**TO:** Jeff Weeder, Galloway and Company  
**FROM:** Amber Wood Hicken, Planner I  
**DATE:** 4/27/23  
**SUBJECT:** Lincoln Professional Park L3 – Andy’s Custard, Site Plan, SP23-113  
Review Comments 03

LINCOLN PROFESSIONAL PARK FILING NO.1 LOT 3

SITE PLAN DOCUMENTS

2 R003 BUILDING ELEVATION - FACING SOUTH FACE (ROAD A)  
 1/4" = 1'-0"

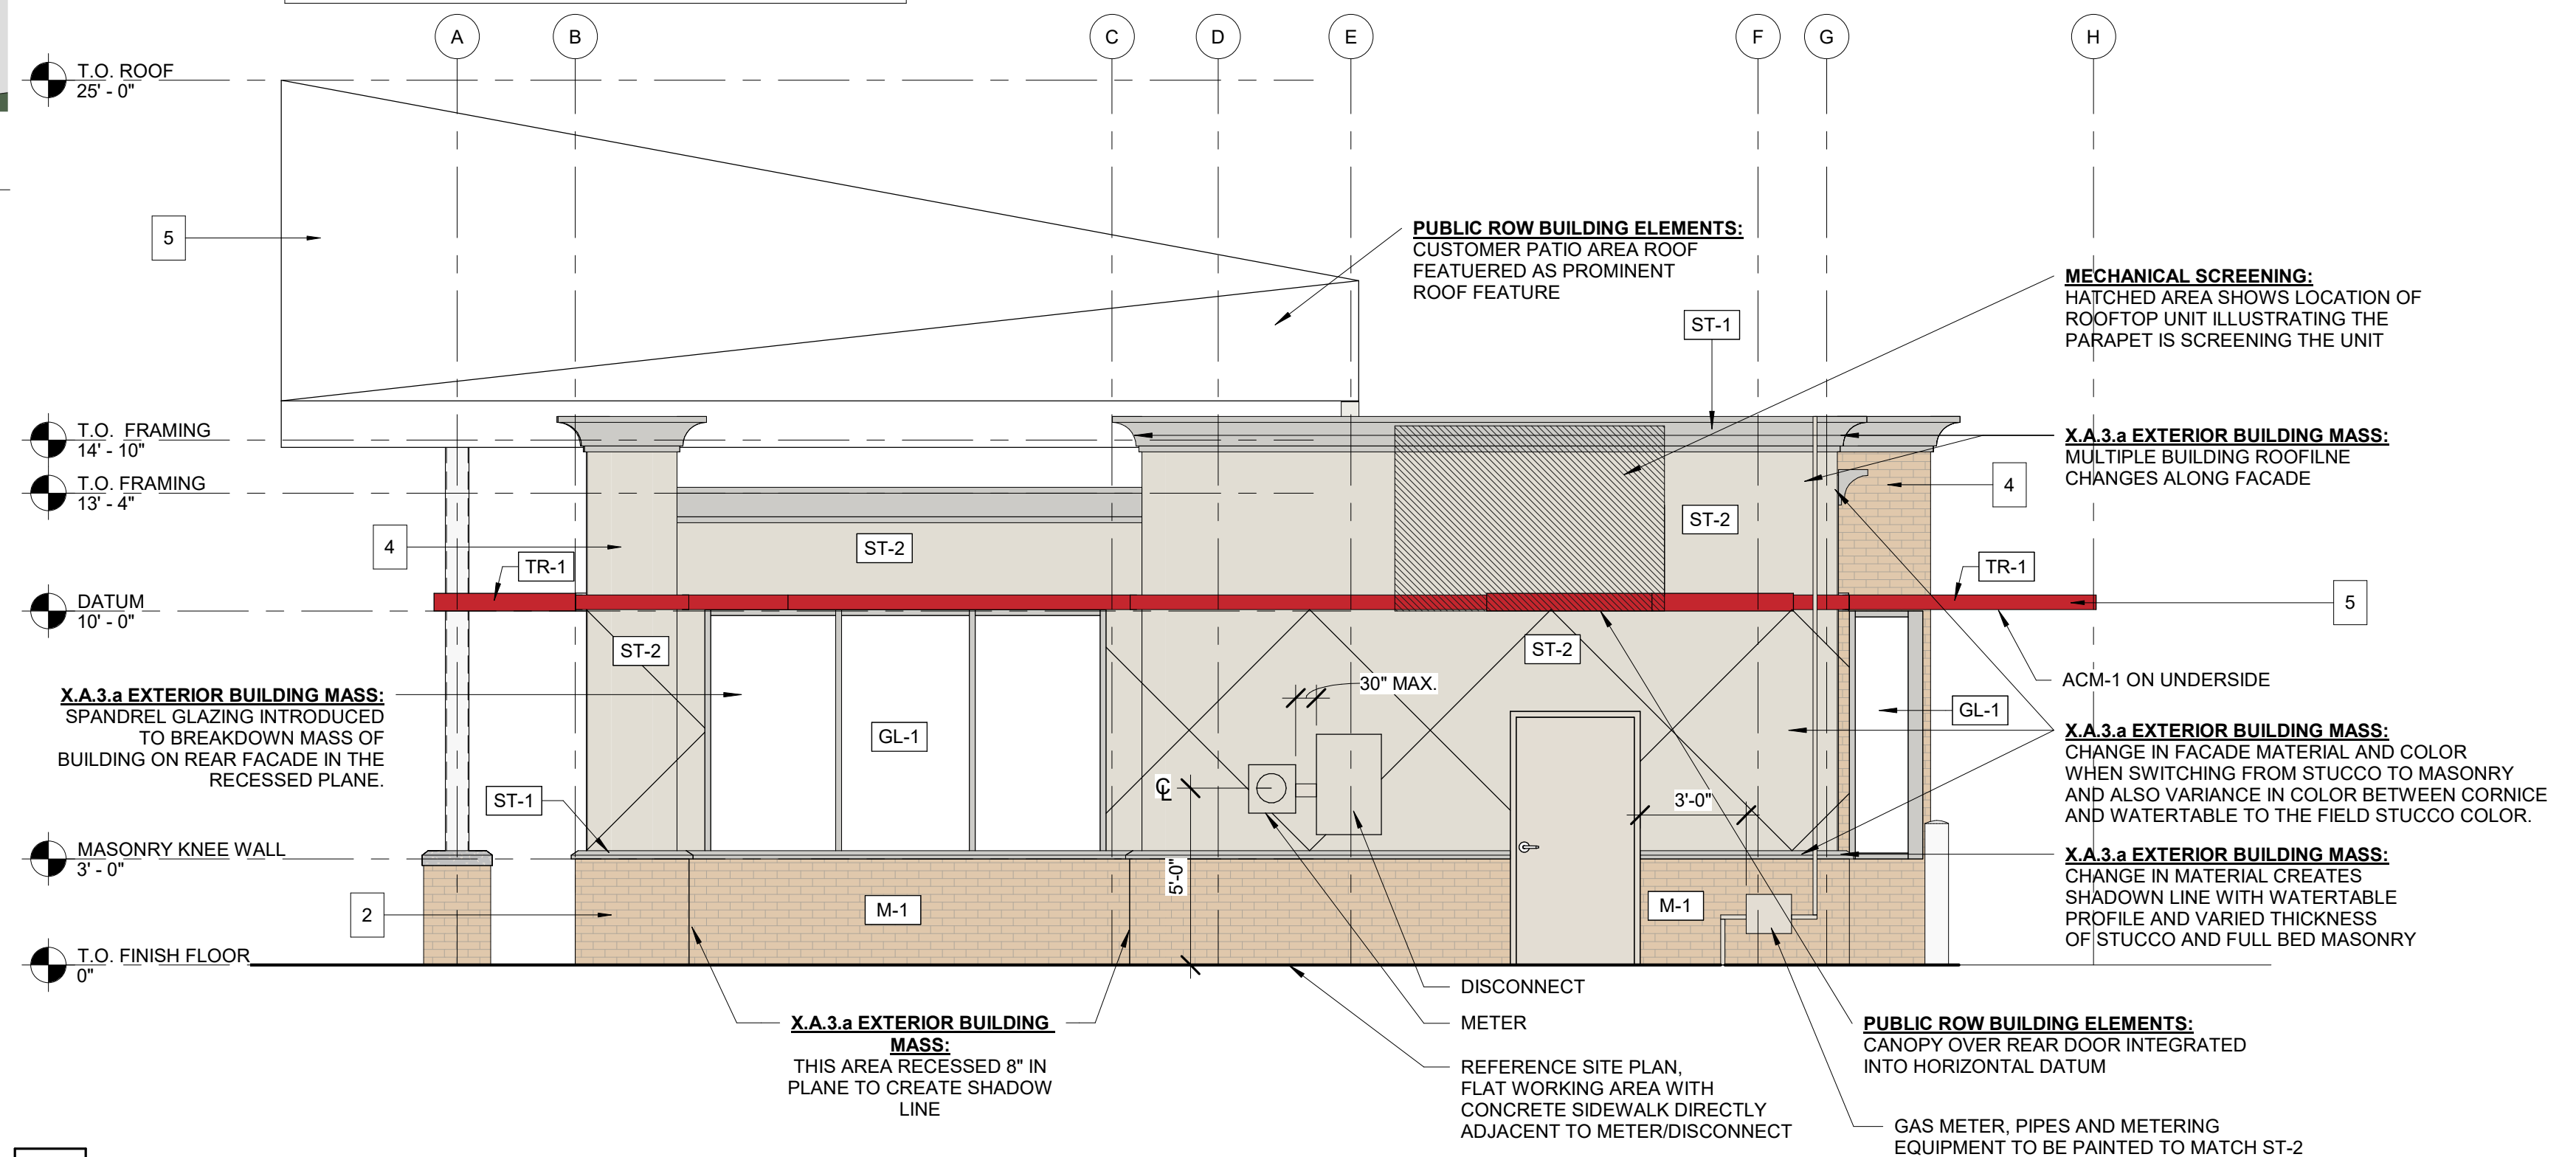
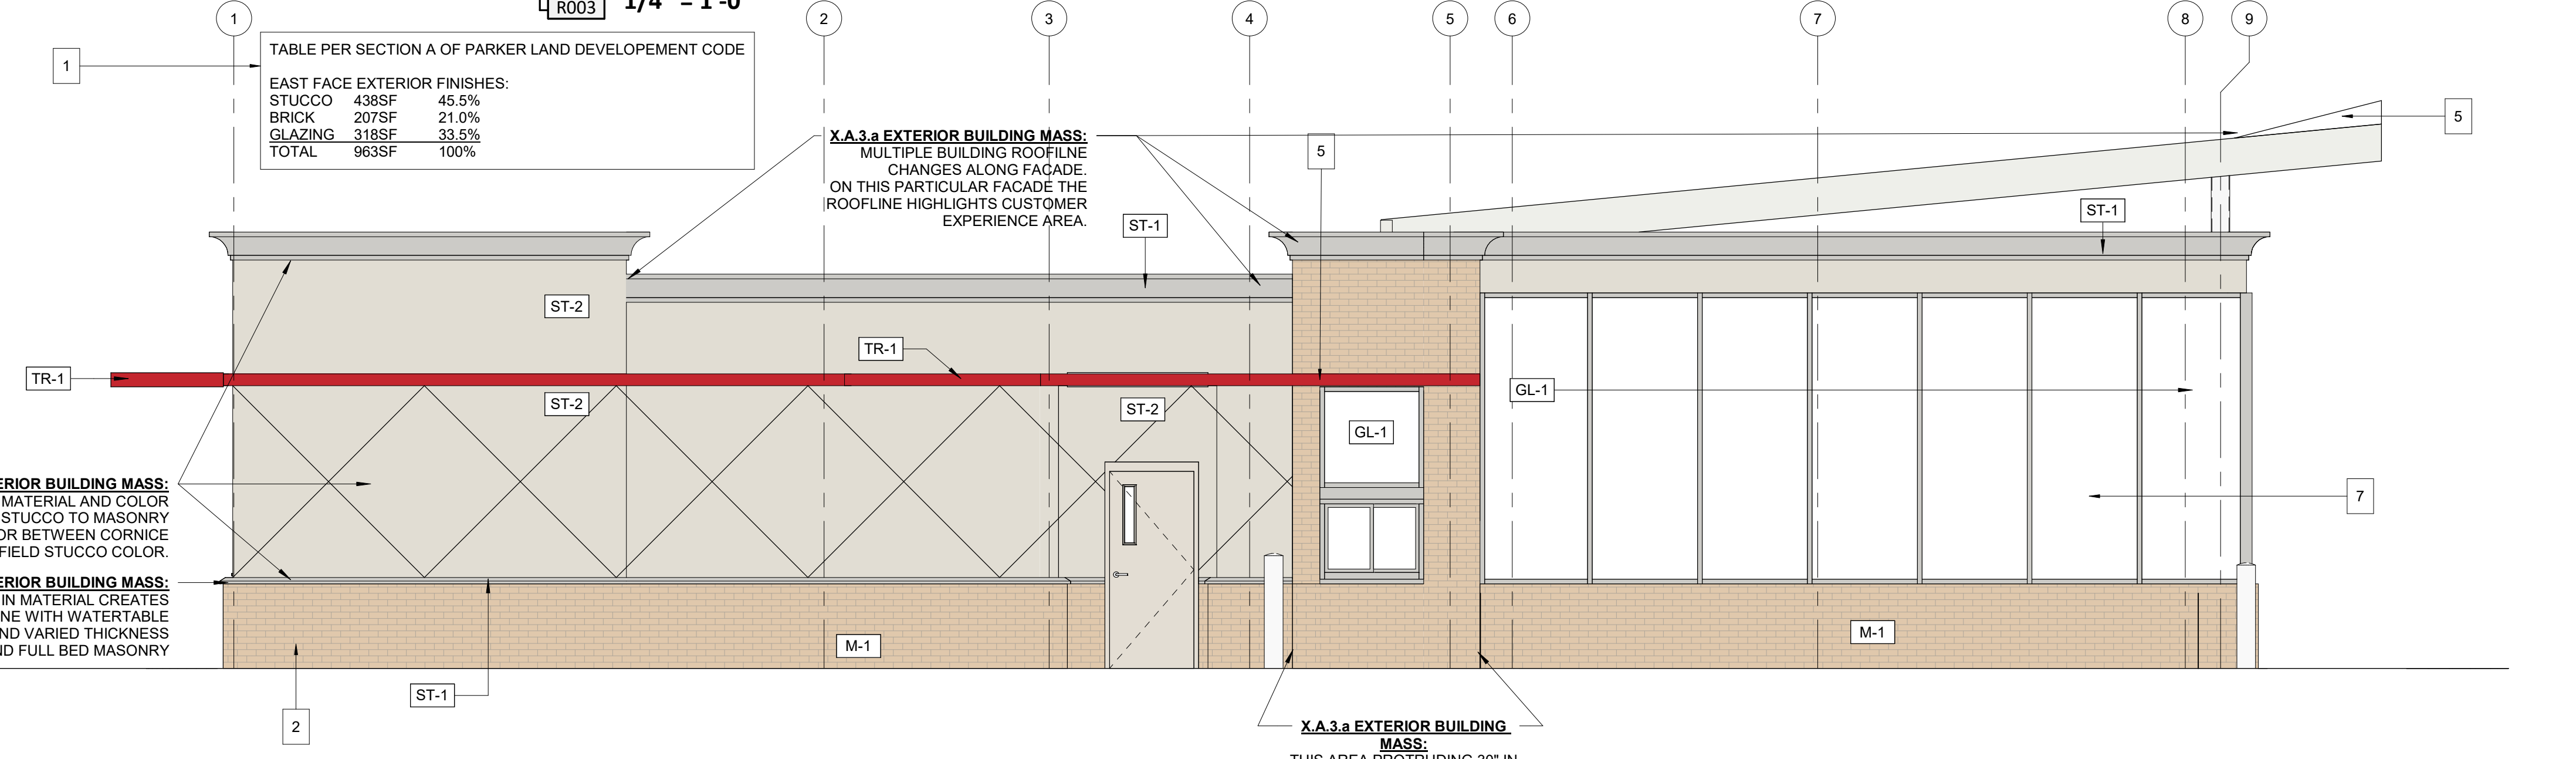
Building must be broken down horizontally (top to bottom) with a base, middle, and top. The middle should include:  
 a) Visibly apparent material change  
 b) String courses (horizontal banding)  
 c) Stepbacks, recesses or protrusions  
 DDS, pg 52

Building must be broken down vertically (left to right), requiring three (3) of the following:  
 1) A change in recesses, protrusions, or changes in the plane of the facade of the building sufficient to create a visible shadow line (see figure 71).  
 2) A significant break in the eave line or roof form  
 3) A change in facade material or color  
 DDS, pg 53
